Re: Port of Portland Comments on Proposed Explanation of Significant Differences for the Portland Harbor Superfund Site

Comments to the U.S. Environmental Protection Agency's Proposed Explanation of Significant Differences for the Portland Harbor Superfund Site

The Port owns Terminal 4 (T4) on the east bank of the Willamette River between river miles (RMs) 4.2 and 5.0 (also known as Sediment Decision Unit [SDU] RM 4.5E). USEPA identified polycyclic aromatic hydrocarbons (PAHs) and polychlorinated biphenyls (PCBs) as the focused contaminants of concern (COCs) at T4. The ROD includes cleanup levels applicable to nearshore sediments (including T4) representative of cancer risk-based carcinogenic polycyclic aromatic hydrocarbon (cPAH) concentrations. These comments focus on implications of the proposed ESD on design, implementation, and overall remedy effectiveness at T4 compared to that of the ROD.

Figure 1
Post-Construction Risks RAO 1 0.5 RMs East and West
 Comments to USEPA's Proposed ESD for the Portland Harbor Superfund Site
 Terminal 4 Remedy

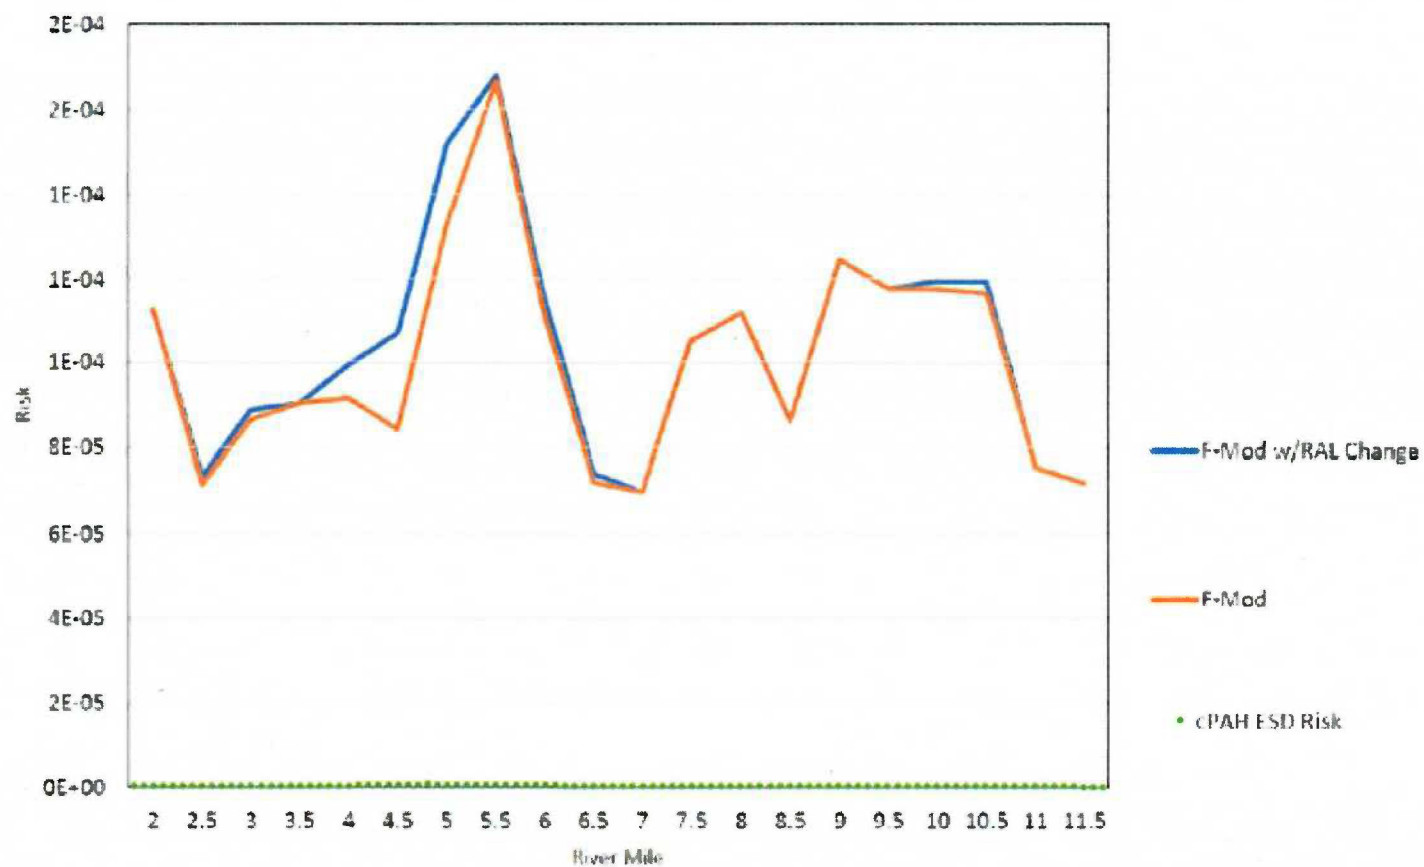
- The new TPAH RAL in the ESD results in the achievement of cPAH risk levels of 1×10^{-6} (Figure 1)⁴ and cumulative risk levels of approximately 5.5×10^{-6} at time zero in all of Portland Harbor (as shown in proposed ESD Figures 9a and 9b)⁵. In contrast, the ROD included the concept of achievement of interim target cumulative risk levels of 1×10^{-5} at time zero, with allowance for subsequent post-construction risk reduction due to ongoing natural recovery.

A revised TPAH RAL applicable to T4 should be more appropriately identified through achievement of a comparable level of post-construction risk reduction and residual risk as that of the ROD-selected remedy. As shown in Figure 1, this evaluation focuses on the 0.5-RM reach within the T4 SDU with the highest existing cPAH concentrations (RM 4.7E). In the ROD, the post-construction SWAC for the selected remedy at RM 4.7E is 337 µg/kg cPAH—3.2 times the RAO 1 PRG (Table 1). In contrast, the proposed ESD remedy results in a SWAC meeting the cleanup level at time zero, with a post-construction SWAC of 0.9 times the RAO 1 PRG. The post-construction 0.5-RM SWAC at RM 4.7E would need to be approximately 2,477 µg/kg to achieve the same level of risk reduction as the ROD selected remedy (i.e., 3.2 times the new CUL) of 774 µg/kg). Anchor QEA, LLC, identified that a revised nearshore RAL of 88,000 µg/kg TPAH⁶ would result in a 0.5-RM SWAC at RM 4.7E of approximately 2,440 µg/kg. That is, a RAL of 88,000 µg/kg (replacing the proposed ESD RAL of 30,000 µg/kg) would achieve essentially the same level of risk reduction as the ROD selected remedy (Table 1).

divergent from previous decisions in the ROD. The Port requests that USEPA revise the proposed TPAH RAL to be consistent with the risk management decisions made in the ROD for selecting contaminant-focused RALs. We estimate the alternative TPAH RAL, consistent with the ROD methodology, would be 88,000 micrograms per kilogram ($\mu\text{g}/\text{kg}$). This alternative TPAH RAL would be applied in the nearshore and would achieve the same level of risk reduction and residual post-construction cPAH direct contact risk as the ROD. It would also be protective of surface water ([remedial action objective] RAO 3) and the benthic community (RAO 5) when applying the same risk management decisions established in the ROD.
